UNITED STATES PATENT AND TRADEMARK OFFICE

Office Action Summary	Application No. 10/534,776	Applicant(s) ARGO ET AL.	
	Examiner Jay R. Ripley	Art Unit 3679

DETAILED ACTION

ATTACHMENT A

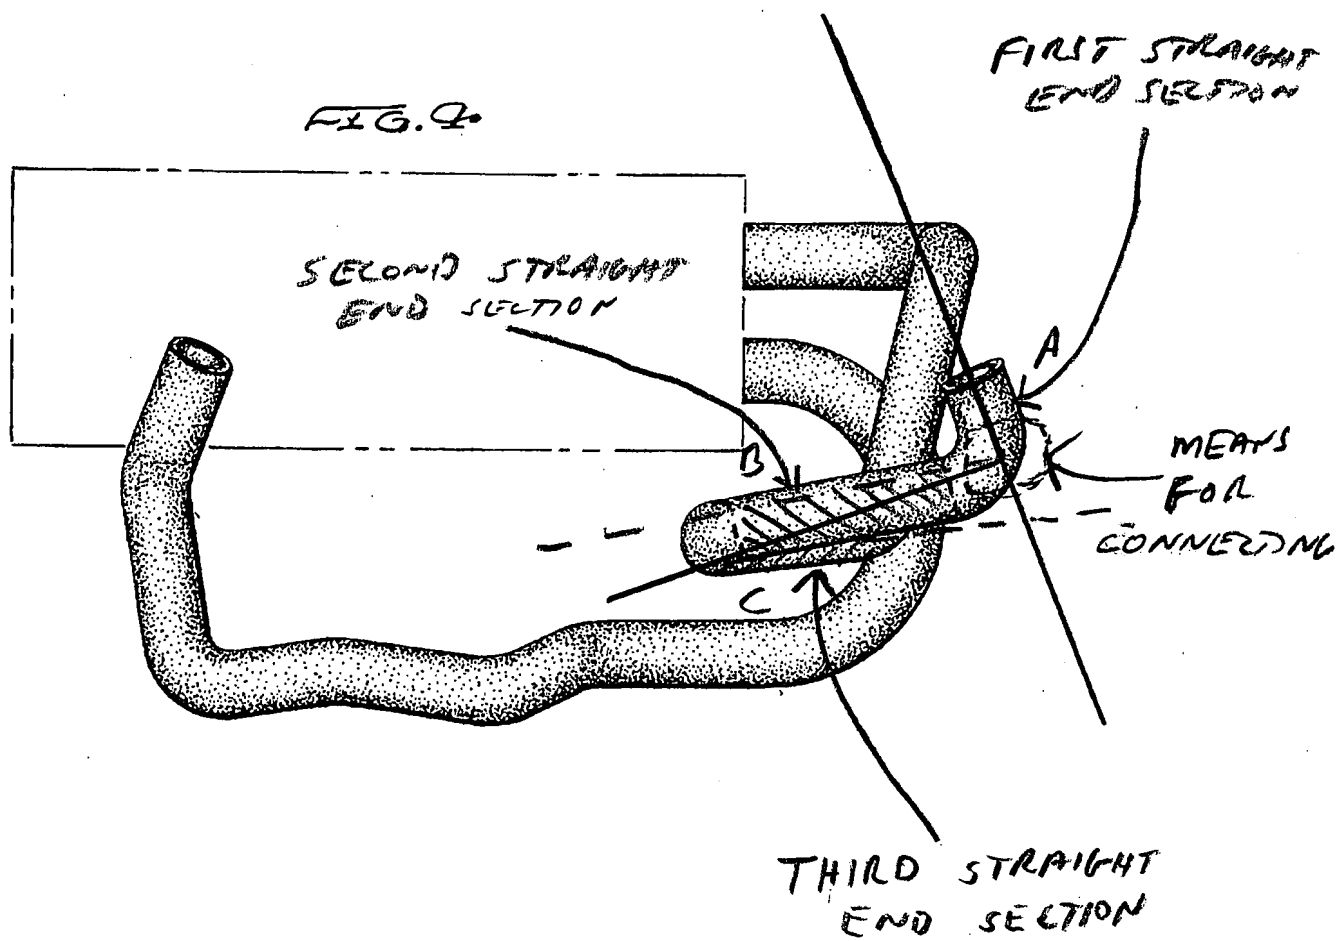
12. In regard to claim 1, Borla discloses in Figures 3 and 4, see Attachments A and B, a fitting, the fitting having a first straight end section (A in Figure 4, see Attachments A and B) positioned along a first centerline and a second straight end section (B in Figure 4, see Attachments A and B) positioned along a second centerline, the included angle between the first centerline and the second centerline differing from a right angle by about 2 degrees \pm ½ degree; wherein the fitting is formed as a single piece.

16. In regard to claim 23, Borla further discloses a third straight end section (C in Figure 4, see Attachment A) positioned along a third centerline, the included angle between the first centerline and the third centerline differing from a right angle by about 2 degrees \pm ½ degree.

17. In regard to claim 24, Borla further discloses that the first straight end portion is connected to the second straight end portion by a curved portion (as observed in Figure 4, see Attachment A) to form a uniform flow path profile.

18. In regard to claim 25, Borla discloses in Figures 3 and 4, see Attachments A and B, a one-piece fitting for tube or pipe, comprising

a first straight end section (A in Figure 4, see Attachment A);

a second straight end section (B in Figure 4, see Attachment A); and

a means for connecting the first straight end section to the second straight end section (as observed in Figure 4, see Attachment A) to form a flow passage that is drainable by gravity when the first straight end section is vertically oriented.

ATTACHMENT B

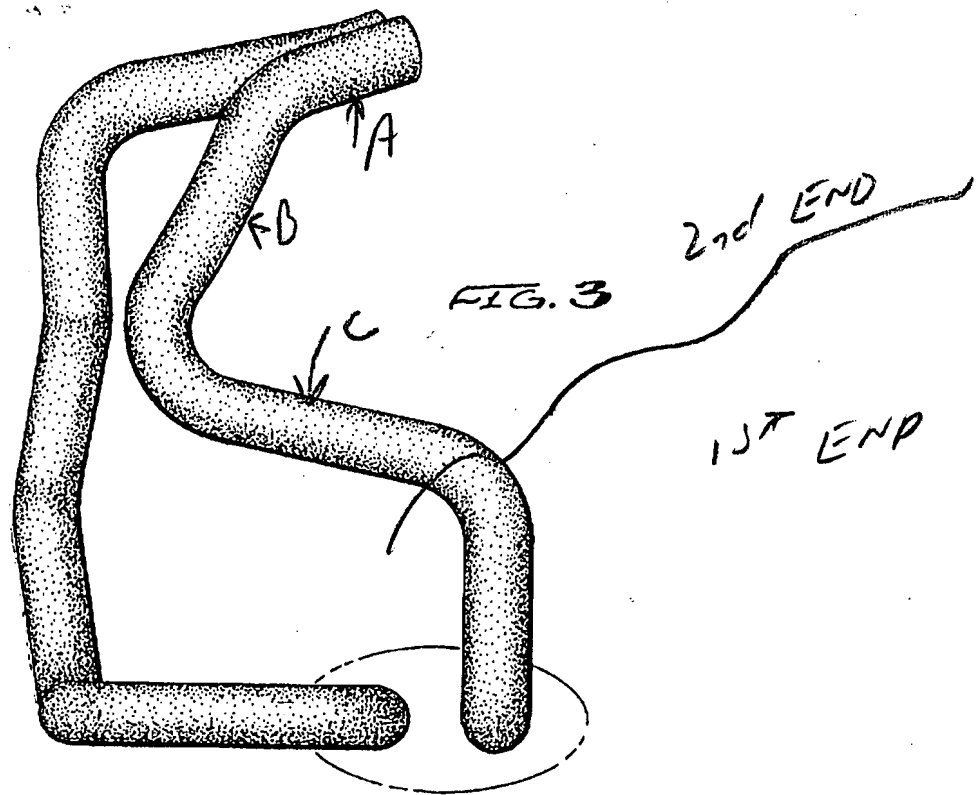
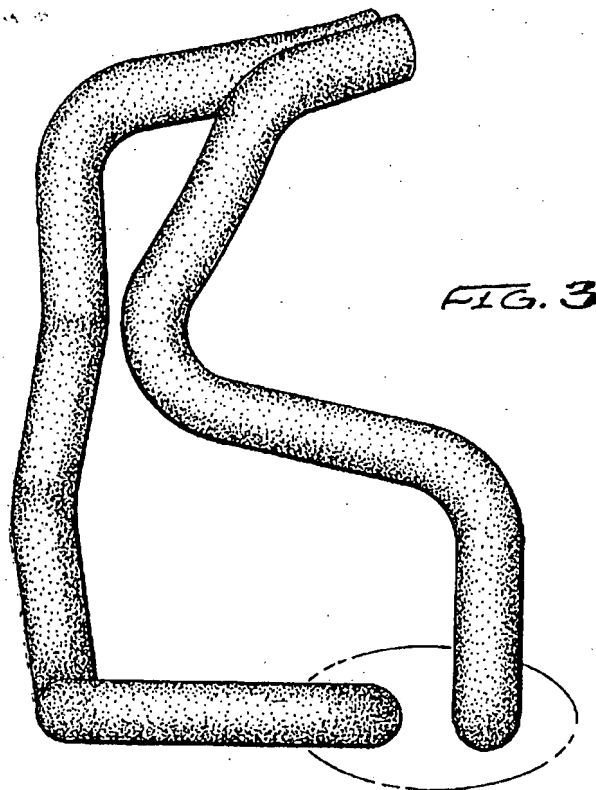
13. In regard to claim 2, Borla further discloses that the included angle is a nominal value of about $88^{\circ} \pm .5^{\circ}$ (as observed in Figure 4, see Attachment B).

14. In regard to claim 3, Borla further discloses that the included angle is a nominal value of about $92^{\circ} \pm .5^{\circ}$ (as observed in Figure 4, see Attachment B).

15. In regard to claim 4, Borla further discloses that at least one of the straight end sections (A in Figure 4, see Attachment B) has an end face that is generally normal to a central longitudinal axis thereof.

19. In regard to claim 26, Borla further discloses that the first straight end section has an end face (as observed in Figure 4, see Attachment B) that extends generally perpendicular to a central longitudinal axis thereof.

20. In regard to claim 28, Borla further discloses that the first straight end section (A as observed in Figure 4, see Attachment B) has a first centerline and the second straight end section (B as observed in Figure 4, see Attachment B) has a second centerline, and wherein the means for connecting (as observed in Figure 4, see Attachment A) the first straight end section to the second straight end section creates an included angle between the first centerline and the second centerline of about $91.5 \text{ degrees} \pm \frac{1}{2} \text{ degree}$. Note that $92 \text{ degrees} \pm .5 \text{ degrees}$ are about $91.5 \text{ degrees} \pm \frac{1}{2} \text{ degrees}$.

ATTACHMENT C

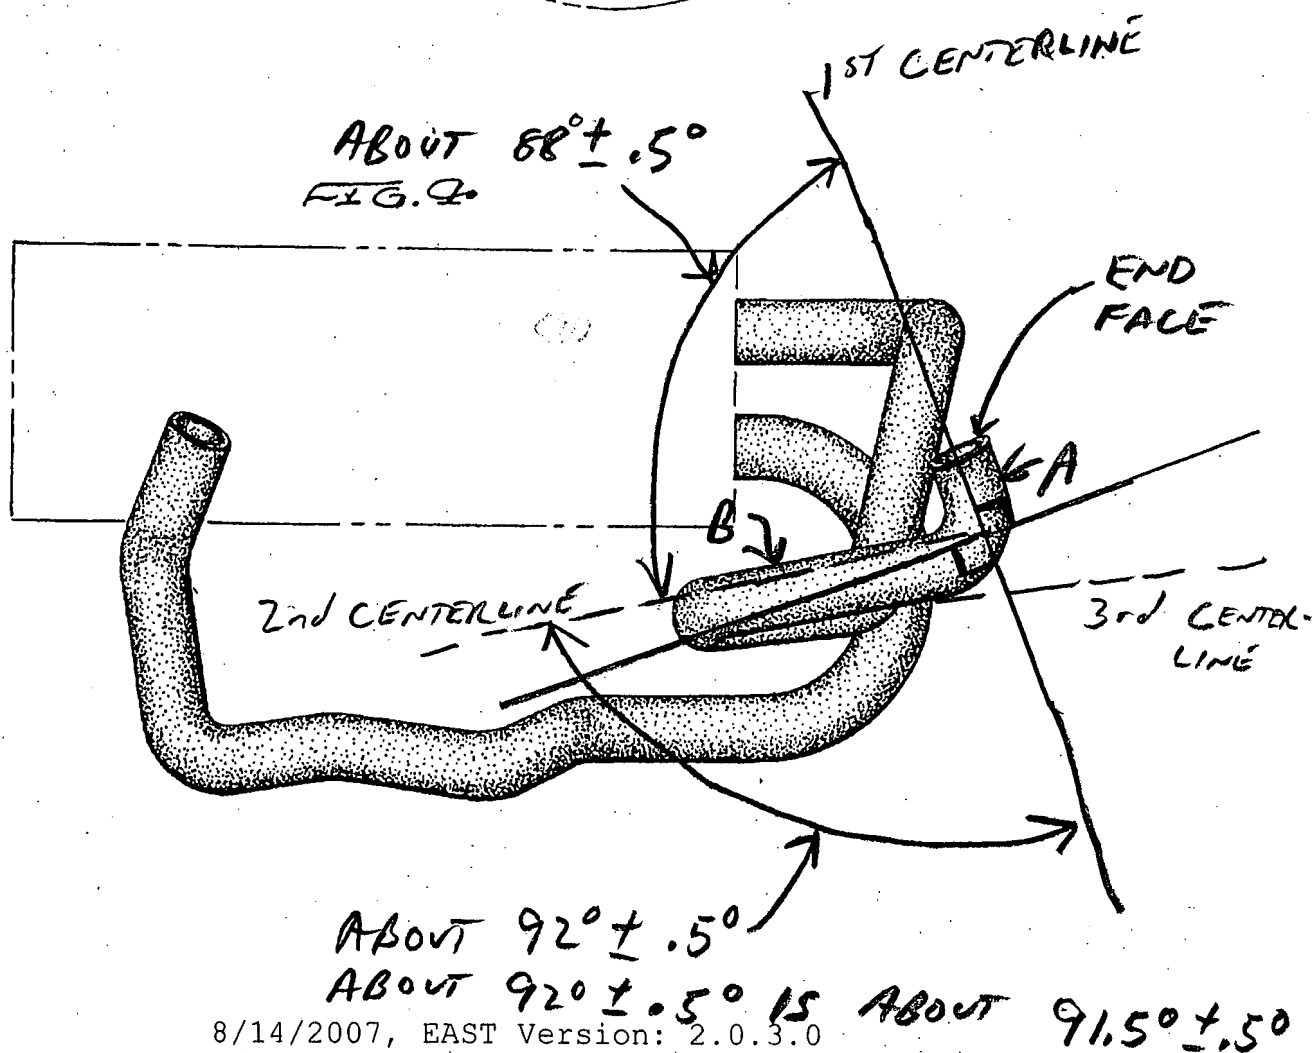
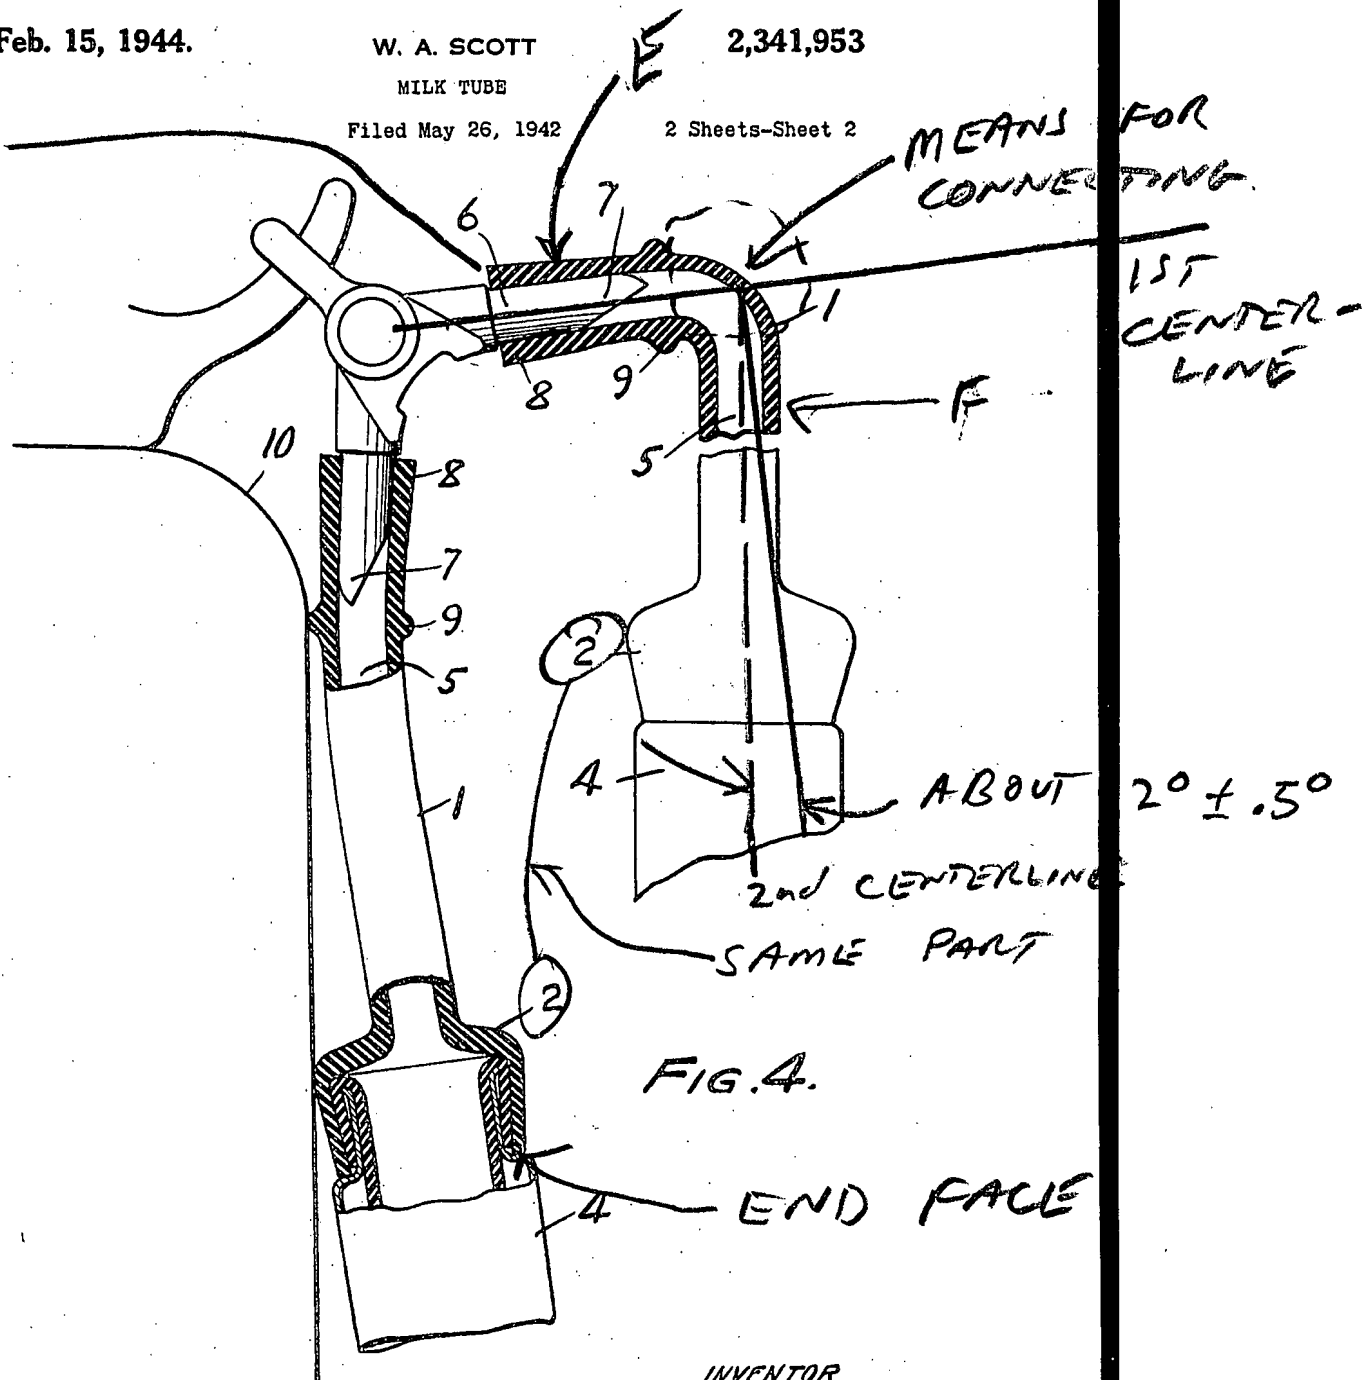
22. In regard to claim 1, Scott discloses in Figure 4, see Attachment C, a fitting, the fitting having a first straight end section (E in Figure 4, see Attachment C) positioned along a first

centerline and a second straight end section (F in Figure 4, see Attachment C) positioned along a second centerline, the included angle between the first centerline and the second centerline differing from a right angle by about 2 degrees \pm ½ degree;

23. In regard to claim 5, Scott further discloses each of the straight end sections has a respective end face (as observed in Figure 4, see Attachment C) that is generally normal to a central longitudinal axis thereof.

24. In regard to claim 25, Scott discloses a one-piece fitting, comprising
a first straight end section (E in Figure 4, see Attachment C);
a second straight end section (F in Figure 4, see Attachment C); and
a means for connecting the first straight end section to the second straight end section (as observed in Figure 4, see Attachment C) to form a flow passage that is drainable by gravity when the first straight end section is vertically oriented.

25. In regard to claim 27, Scott further discloses that each of the straight end sections (E and F as observed in Figure 4, see Attachment C) has a respective end face (as observed in Figure 4, see Attachment C) that extends generally perpendicular to a central longitudinal axis thereof.
